Plat Name: Robertson's addition to Bethesda
Plat #: 220131090

SUBDIVISION RECORD PLAT
PROJECT: LOTS 11 & 12, BLOCK C
ROBERTSON'S ADDITION TO BETHESDA
THE MONTGOMERY COUNTY PLANNING BOARD
MONTGOMERY COUNTY, MARYLAND
WITMER ASSOCIATES, LLC
Land Surveying, Land Planning & Design
18401 Woodlands Road, Suite C, Gaithersburg, MD 20878
Tel: (301) 760-1400 Fax: (301) 760-1401
November, 2012 08979 B 1 of 1
Scale: 1" = 20'

MINOR SUBDIVISION PLAT REVIEW SHEET

Plat Name: Robertson Addition to Bethesda Plat Number: 22031090
 Plat Submission Date: 1-29-2013
 DRD Plat Reviewer: S. Smith
 DRD Prelim Plan Reviewer: N/A

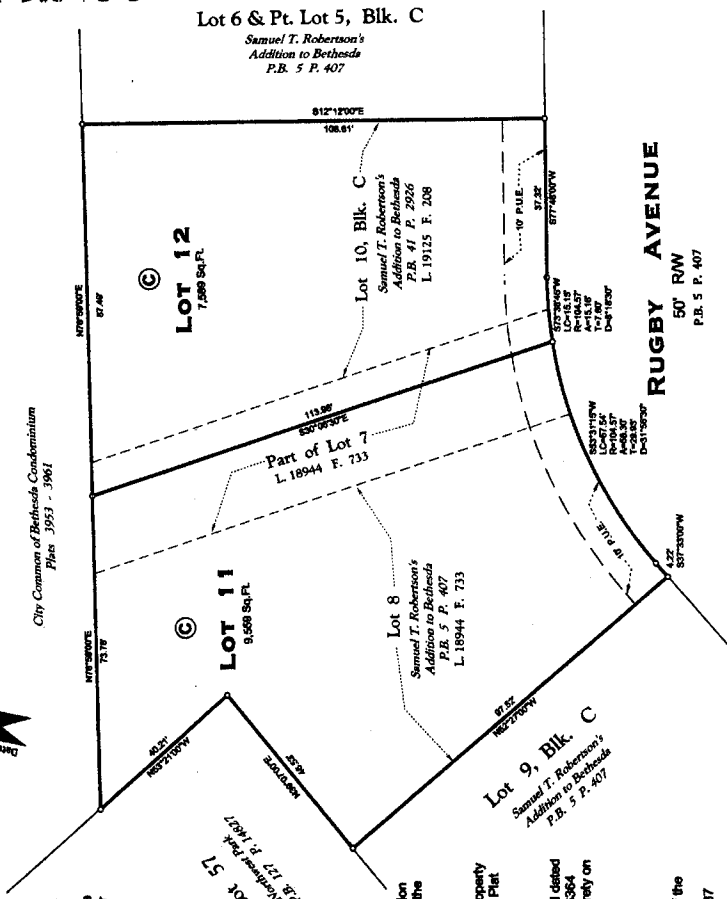
Agency Reviews Req'd	Reviewer	Date Sent	Due Date	Date Rec'd	Comments
Environment	Evelyn Gibson	1-30-13	2-15-13	2-1-13	No Comments
Research	Bobby Fleury			1-31-13	
SHA	Corren Giles				Add Datum
PEPCO	Bobbie Dickey			2-5-13	Show PVE
Parks	Doug Powell				
DRD	Keiona Clark
